**Boral Construction Materials**

**St Peters Modification 8**

Further to comments received by the Department of Planning and Infrastructure (DP&I) from Marrickville Council (Council) and the Roads and Maritime Services (RMS), please find below responses to each of the matters raised.

Figure 3: Entry and exit points for the site

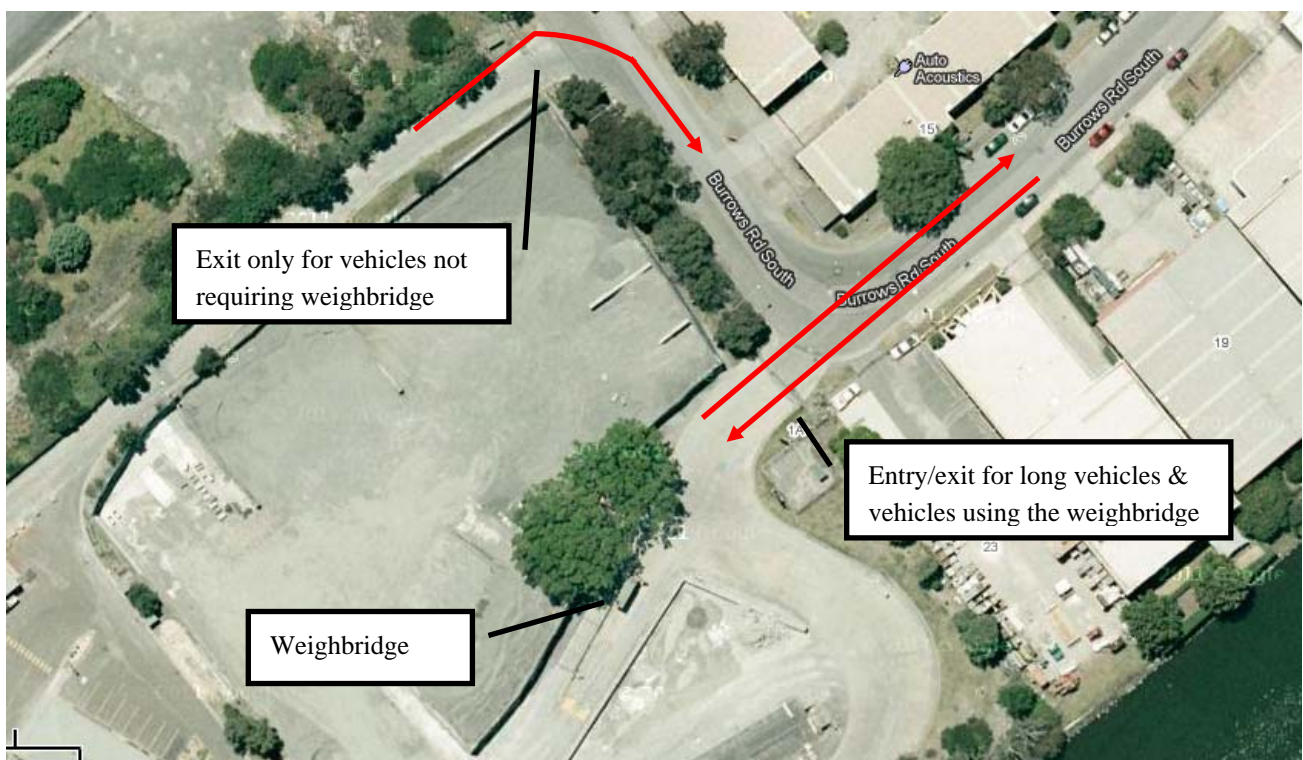
The RMS have requested a swept path plan of the longest vehicle accessing the site for construction purposes. The longest vehicle that is anticipated to access the site for construction is a b-double (27.5 metres). B-doubles currently access the site for the collection of quarry products and product delivery to the concrete batching plant via the southern most entry/exit point. Figure 3 below shows the entry and exit point to the site for long vehicles such as b-doubles. Long construction vehicles accessing the site will also use this southern entry /exit point.

As demonstrated in figure 3 above, long vehicles do not currently need to turn to gain access to or exit the site, and instead can simply drive in a straight line onto and off Burrows Road South. We therefore propose that a swept path plan is not necessary for this modification.
